Advisory Action Before the Filing of an Appeal Brief	Application No.	Applicant(s)	
	10/696,757	SOLLARS, JOHN A.	
	Examiner Eric Culbreth	Art Unit 3616

THE REPLY FILED 24 January 2006 FAILS TO PLACE THIS APPLICATION IN CONDITION FOR ALLOWANCE.

CASE 2056B
SERIAL # 09/884,541
INFLATABLE AIRBAG AND METHOD OF MAKING THE SAME
SOLLARS

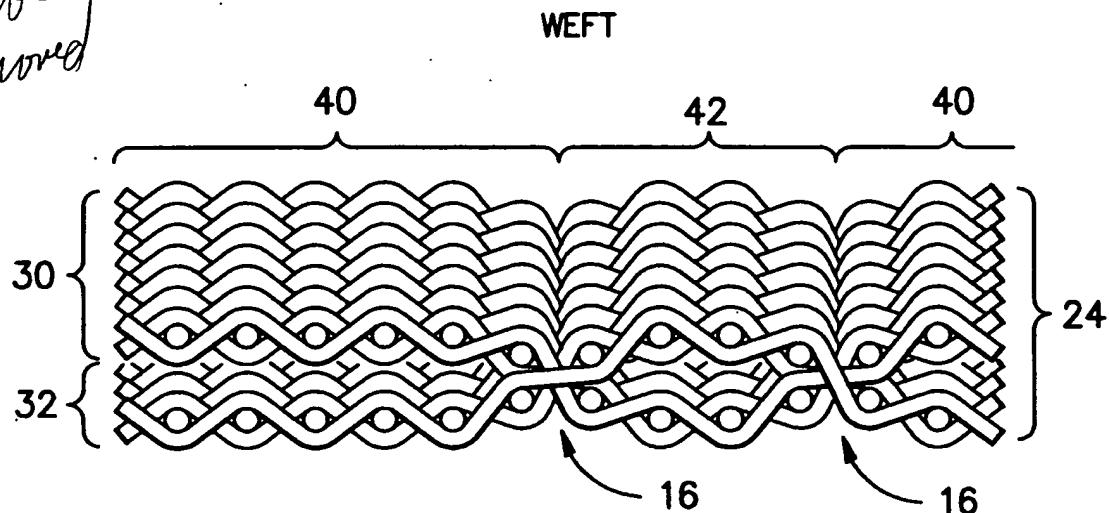
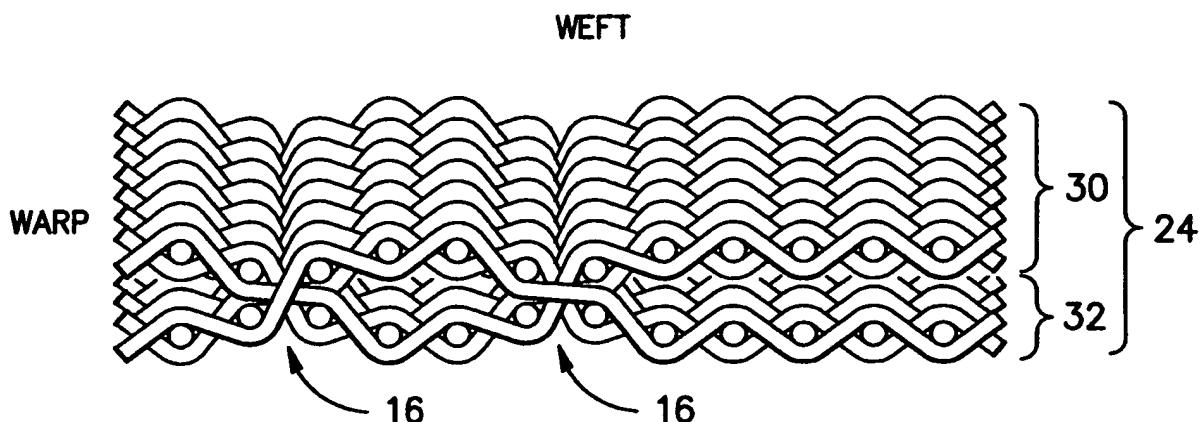
Continuation of 3. NOTE: The replacement sheets filed 1/24/06 and 9/16/05 are not approved because they have the wrong application serial number at the top of the page (this is application 10/696,757, not 09/884,541); this will cause confusion should the case issue. Otherwise, changes in the replacement sheets are acceptable. Upon reconsideration, the jacquard weave is adequately illustrated. The objection to the drawings not showing the claimed interconnected joint in the weft direction is maintained (noting applicant's remarks, Figure 6 does not show the interconnected joint in the weft direction, and describing the joint on page 8 of the specification does not meet Rule 37 CFR 1.83 (all claimed features must be shown). Regarding 112 issues raised in the final Office Action, claim 10 is still indefinite because there is no clear antecedent basis for "the weft direction" and "the warp direction" ("a weft" and "a warp" would be a better recitation). The limitations added to claim 25 raise new issues requiring further search and consideration. The remarks are not persuasive because in Figure 4 of Buchner et al, at 23, crossover of warp/weft yarn 24 from one layer to the other on one side of 23 and crossover back to the one layer on the other side of 23 .

*Not
Approved*

CASE 2056B
SERIAL # 09/884,541
INFLATABLE AIRBAG AND METHOD OF MAKING THE SAME
SOLLARS

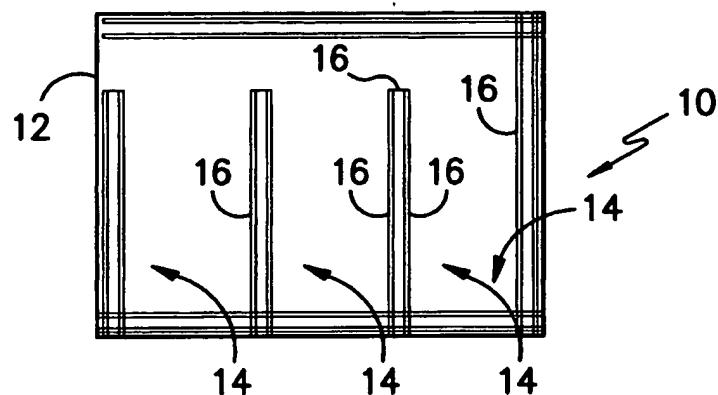
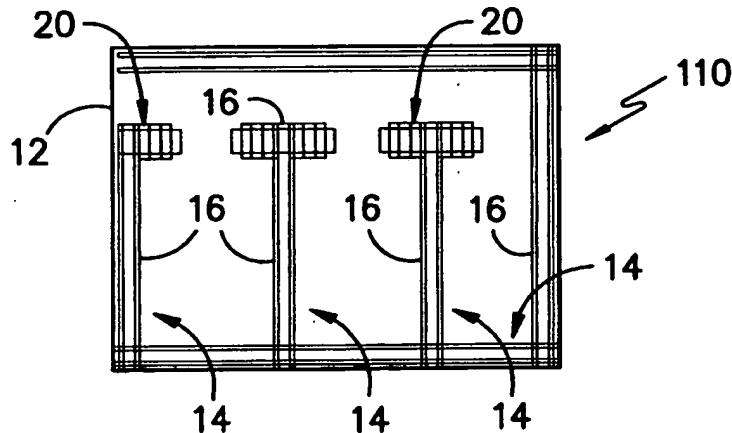
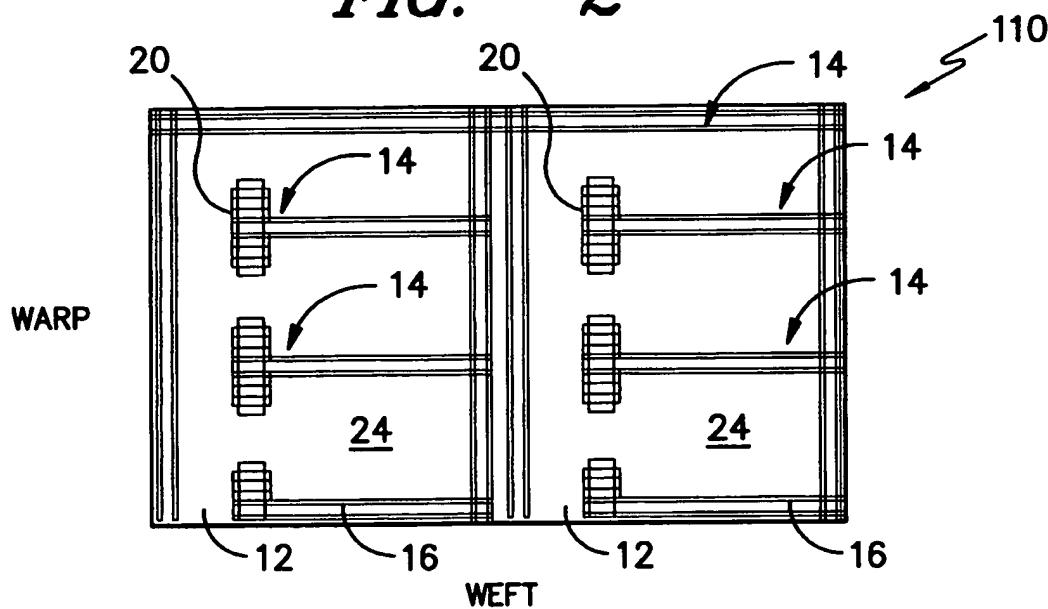
Not
Approved
EC 1/31/06
